I wish to submit a "Submission against approval" for DA 2023/1832, 5 Portions DP 590990, 5 Portions Lovett Bay as per the above attachments.

OBJECTIONS AND COMMENTS ON DA 2023/1832

By Robert Story and Susan Duncan, additional to Helen Monks,
Town Planner

5 PORTIONS, LOVETT BAY NSW

DRG-01
LEPLASTRIER HOUSE
NEIGHBOUR INTERACTION

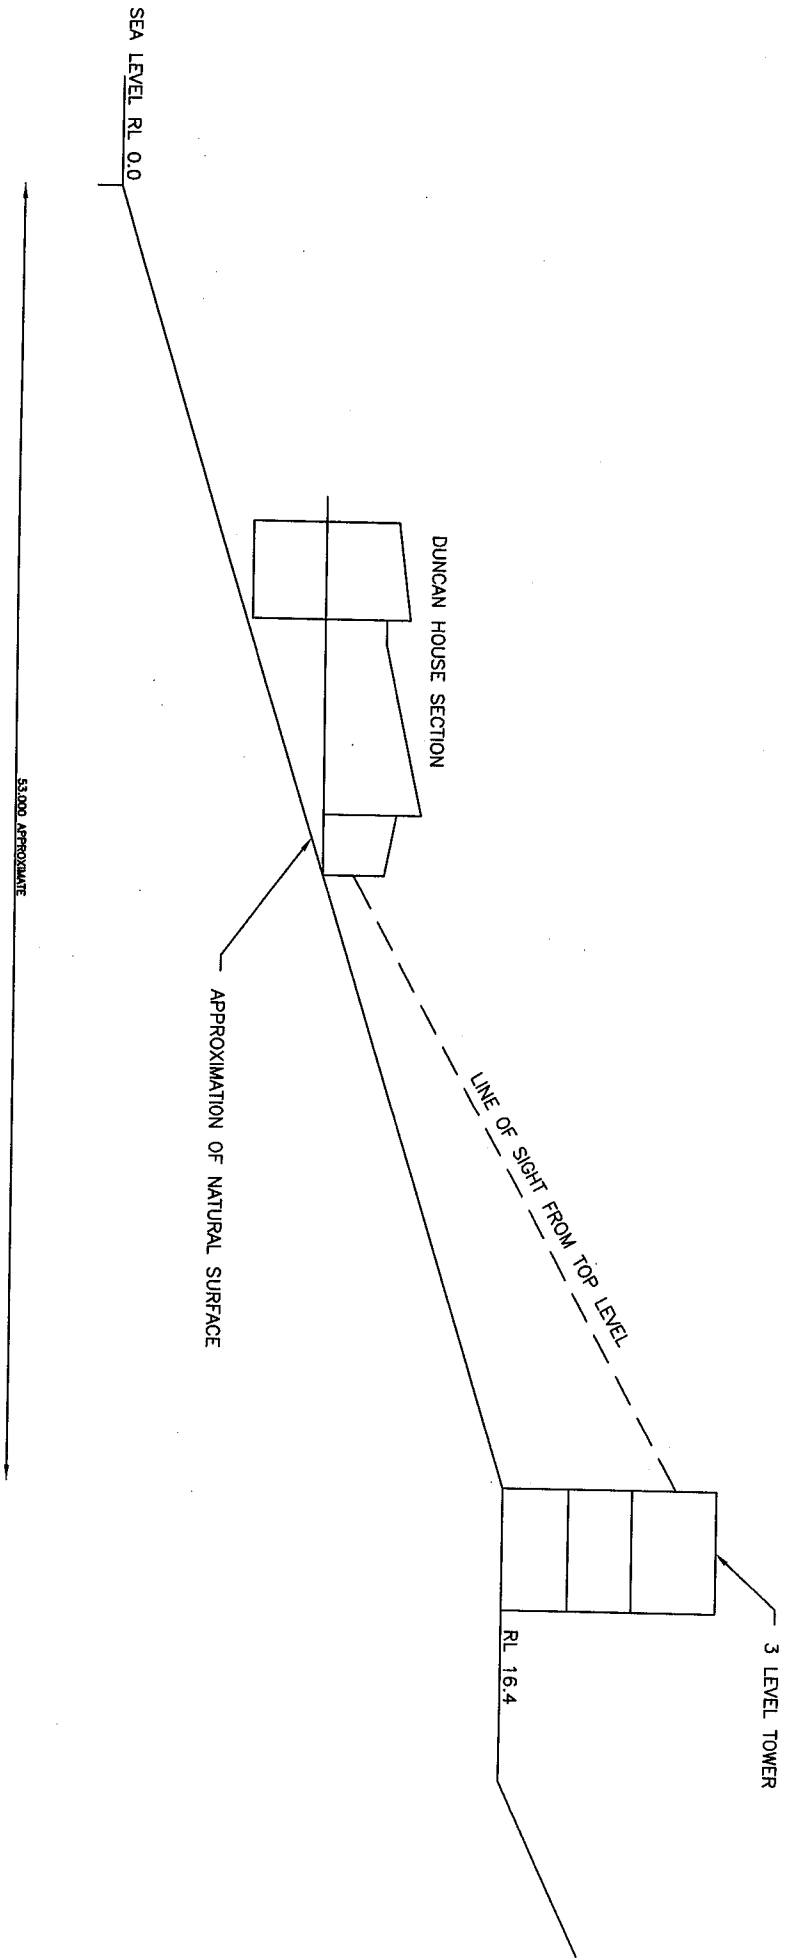
2.7 Exposure: Steep terrain (45 degrees) above Lot 5 means there is virtually no sun in winter (see drawing DRG-01). The absorption trench would be shadowed by the house for more than six months of the year. This makes 2.7.1 site exposure limitations moderate.

2.8 Slope: The average slope from seashore to the back of Lot 5 building area is approximately 20 degrees which makes Lot 3 and Lot 6 vulnerable to significant leakage of the proposed absorption trench. Refer to drawing DRG 01 for trench location.

Figure 3.1: Profile Cross-section south to north (site building envelope in blue)

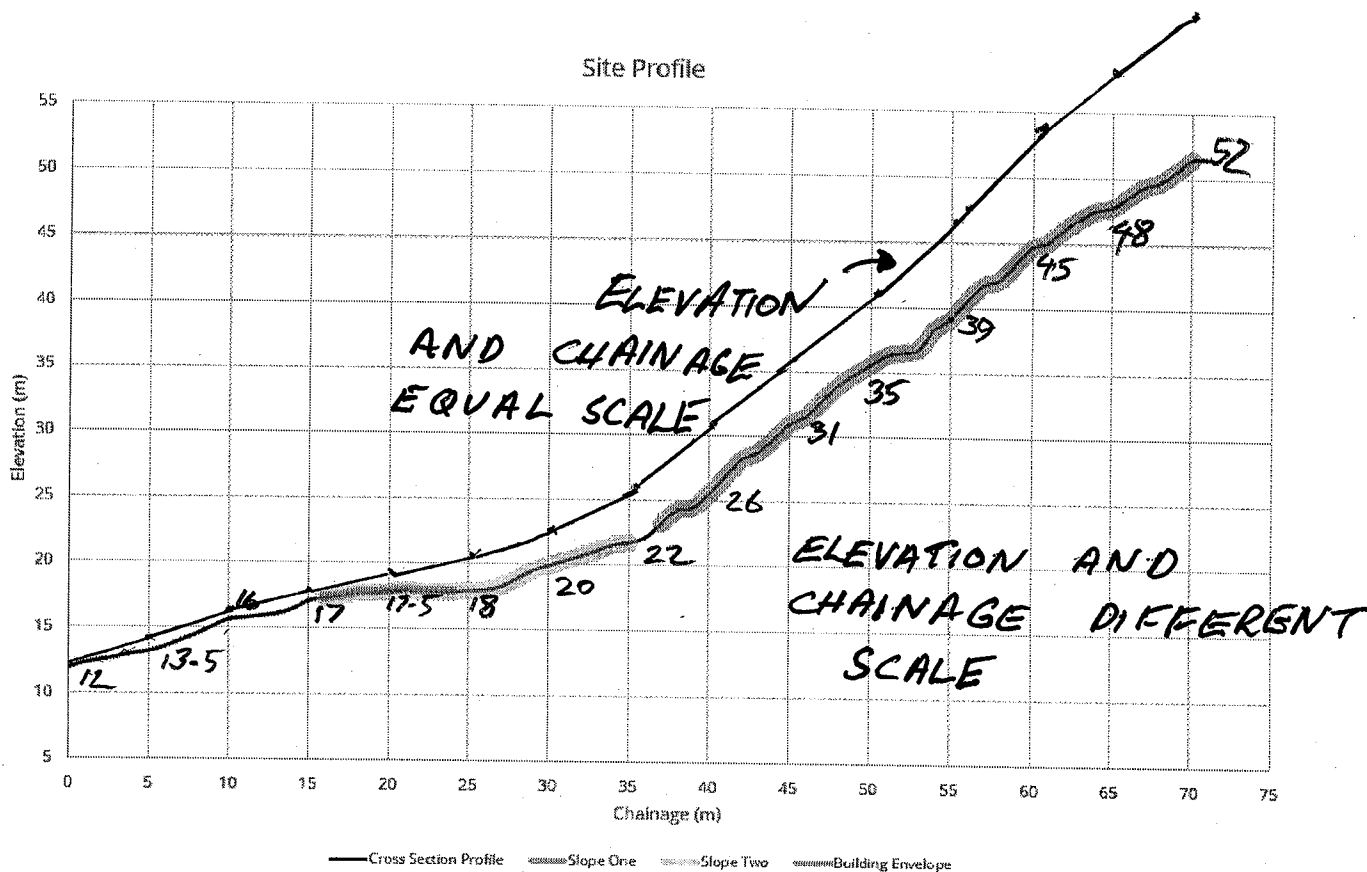
Figure 3.1 profile cross-section is misleading. The elevation and chainage are different scales, giving a shallower appearance of the slope of the land.

Refer to DRG-04 The block is steeply sloping from the water's edge, starting at 20 degrees and increasing to 45 degrees.

DRG-05 BOUNDARY ERROR
APPENDIX A

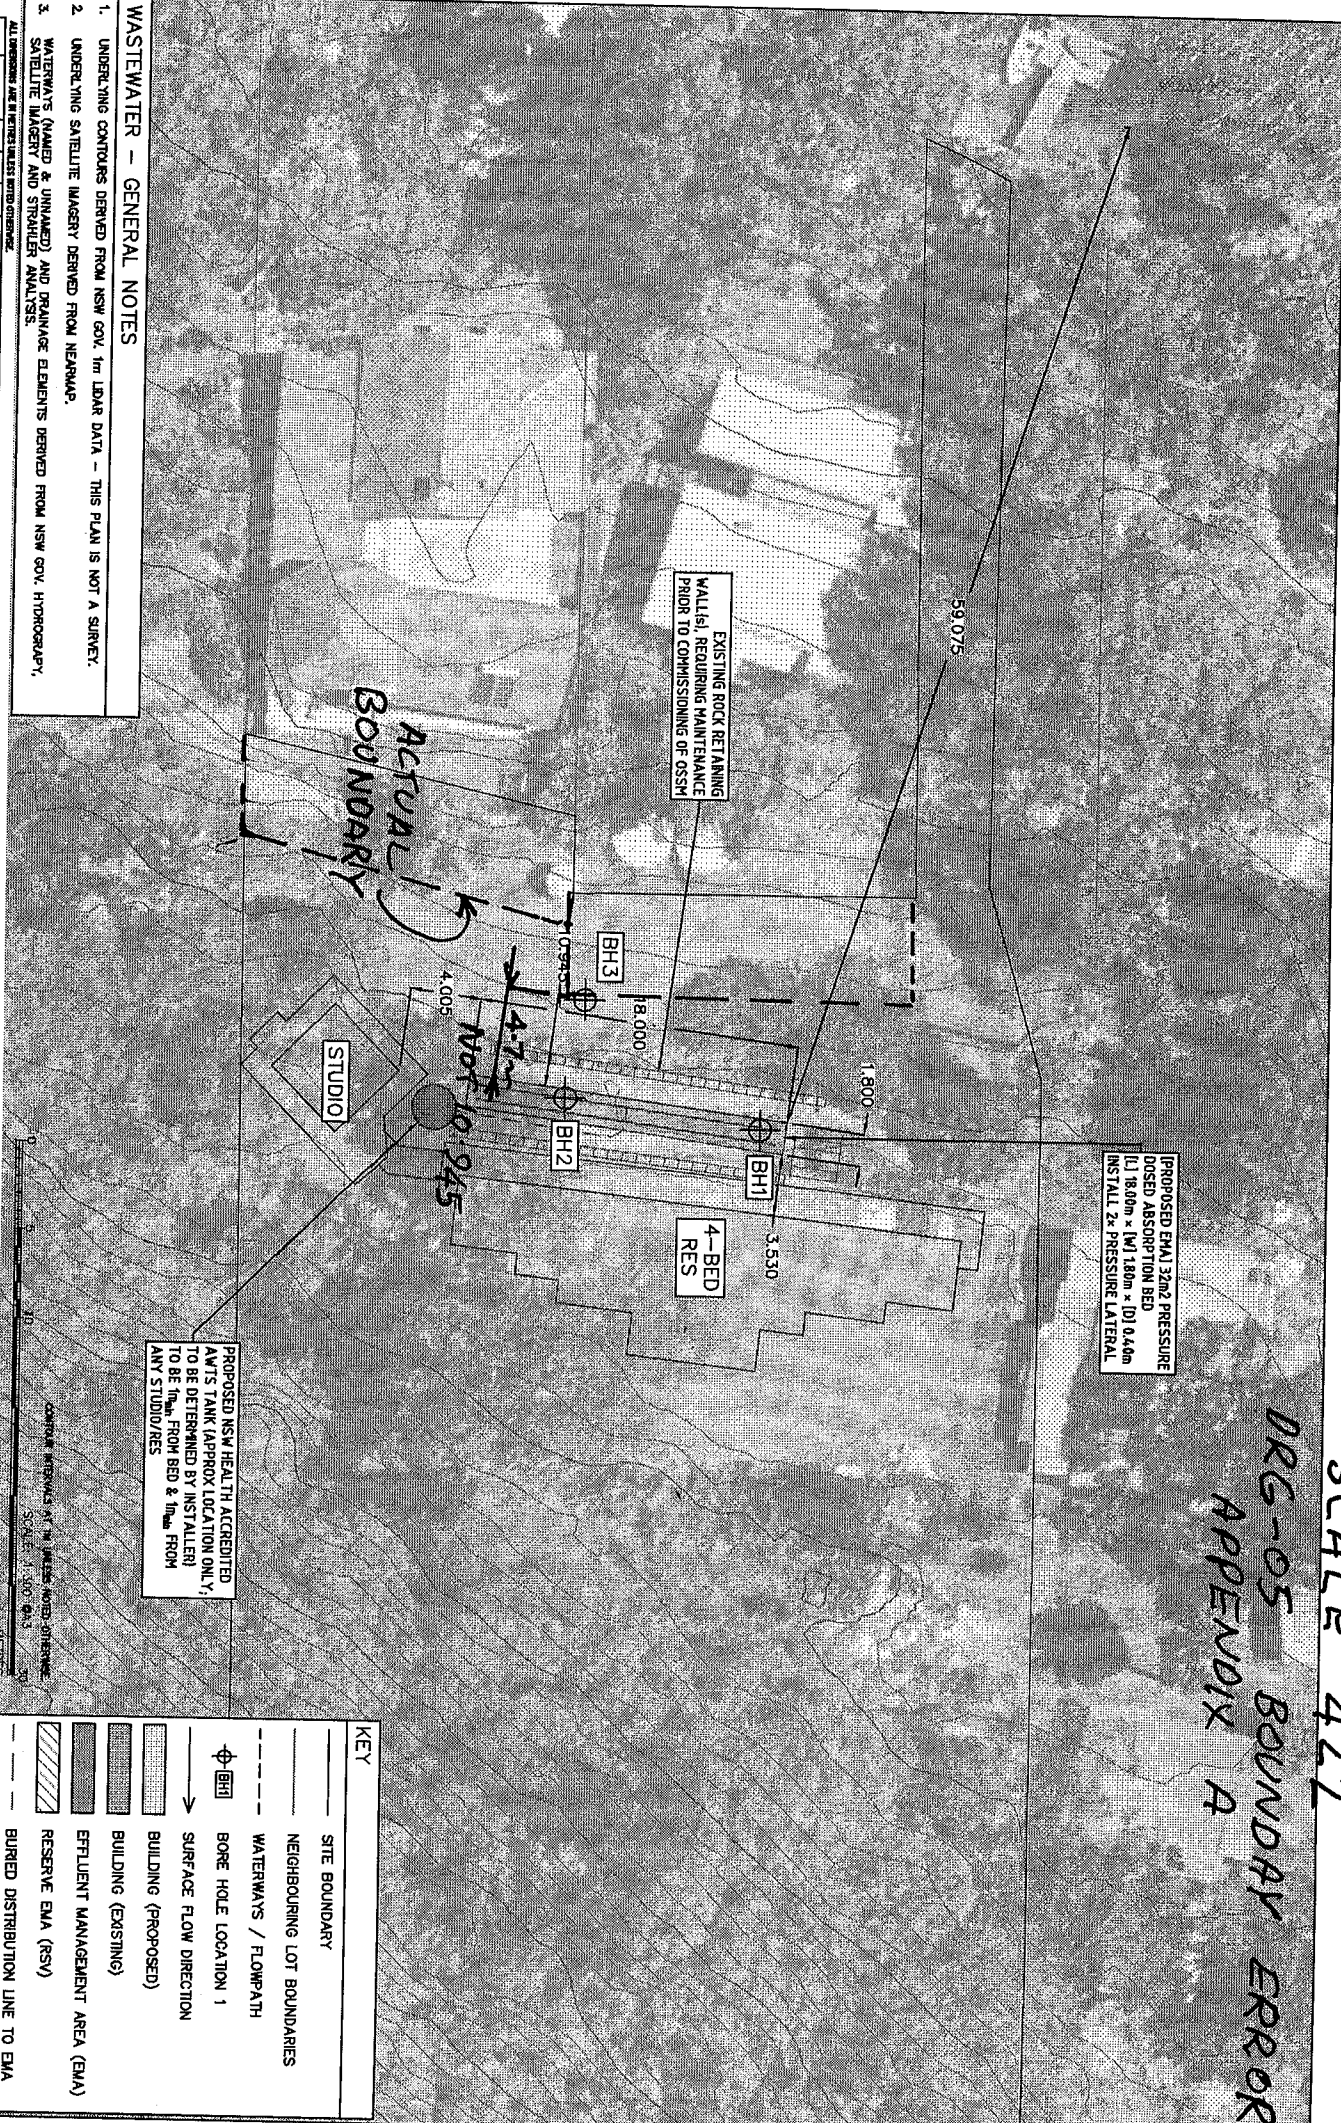
E Position of land application area in landscape: boundaries are incorrectly shown on Appendix 1 and are out by a distance of **7 meters**.

Appendix 1: Boundaries of Lot 3 and Lot 6 incorrectly drawn and show a major discrepancy of 7 meters. See drawings 5 & 6.

1. EMA is far too close to 3 Portions boundary and must be located at least 12 meters off this boundary.
2. Appendix 1 of the wastewater report shows the Portion 3 property boundary to be approximately 7 metres south of the actual location.

DRG-07 SHADOW LINE

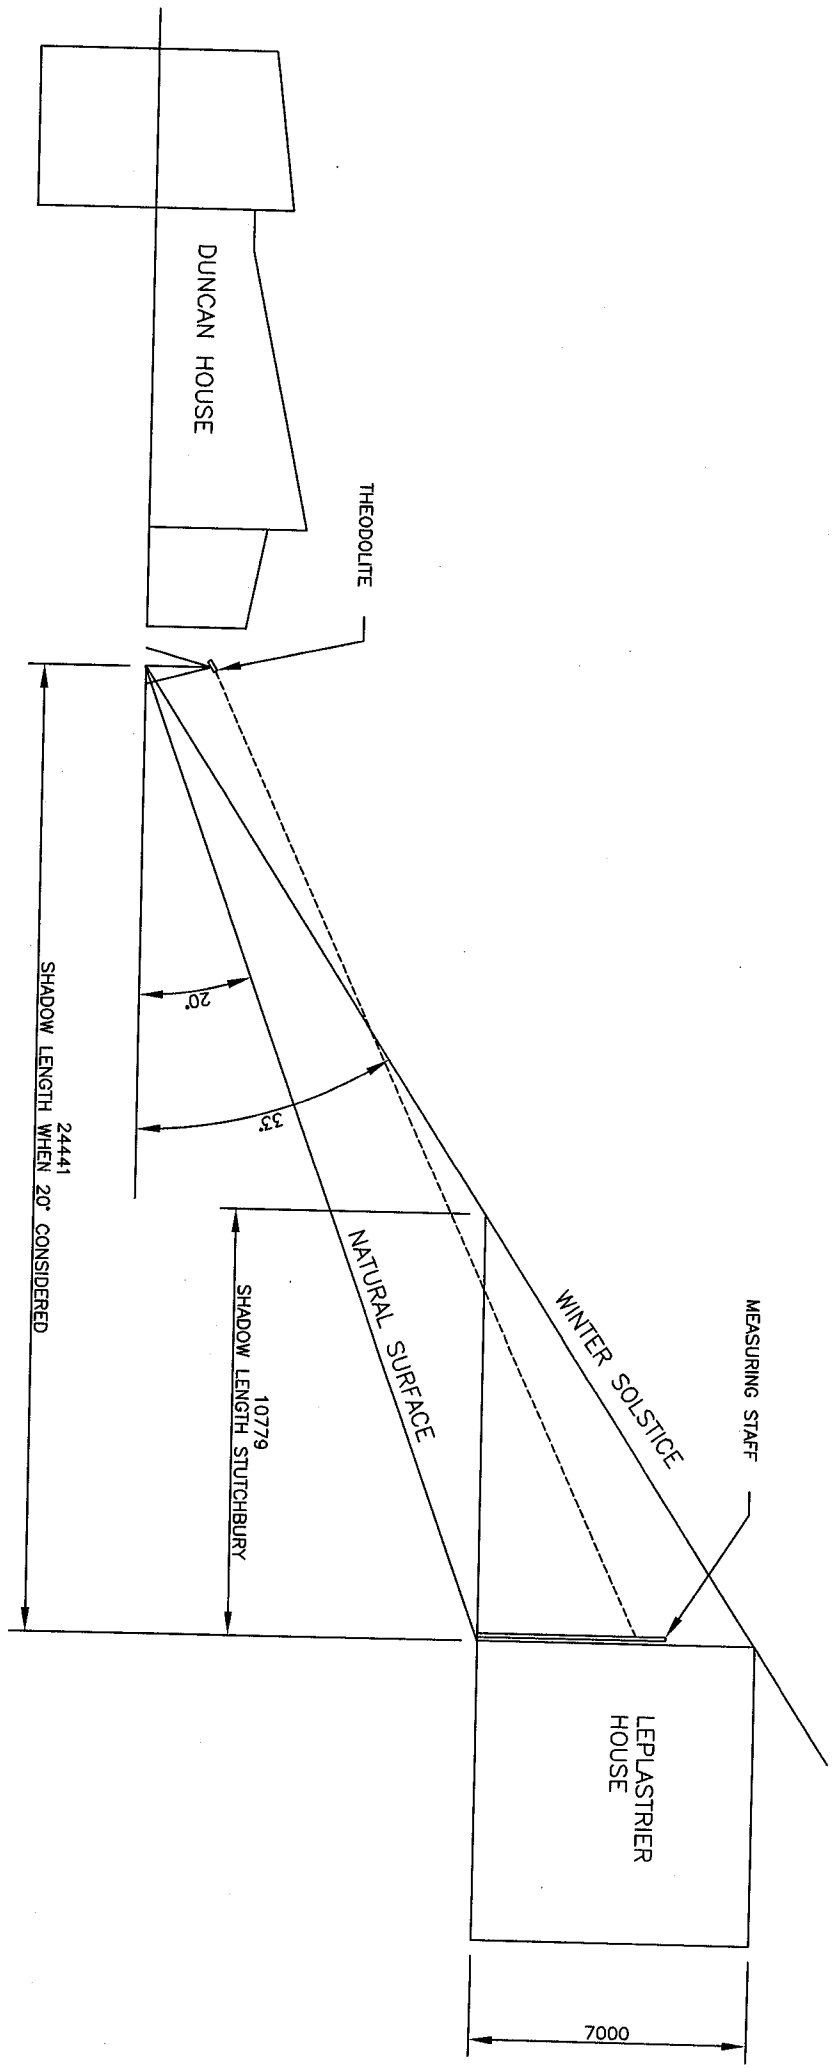
There is a fundamental error in the shadow lines provided. *See DRG 01, 07,08.*

Analysis does not take into account that the land between 5 Portions and 3 Portions, falls steeply away at around 20 degrees. The shadow lines chase the sloping land until the shadow line catches up. Shadow length is around 11 metres, whereas I have calculated a shadow of approximately 25 metres. **See DRG 07.**

We can argue the correct shadow length, but the simplest solution is to carry out a site measurement. A theodolite can be set up at the Duncan House to sight a measuring staff at the Leplastrier designed building at the front elevation. Knowing the distance and the angle, an accurate drawing can be compiled. **See DRG -07.** No surveyor is required as I have a theodolite and can do a full and accurate check with a representative of the Leplastrier family.

DRG-08

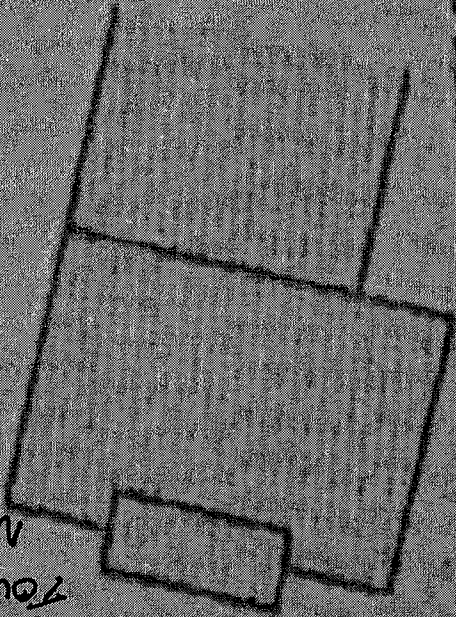
3. 5 Portions site is subject to high moisture content especially in heavy rains resulting in intermittent and semi-permanent springs.
4. Geotech report misrepresents the steepness of the site and the problems with water run-off.
5. Shadow lines are grossly understated and need to be reinvestigated. The shadow of the house would come to the back door of 3 Portions, which means that main building and the tower would dominate the view from that position.
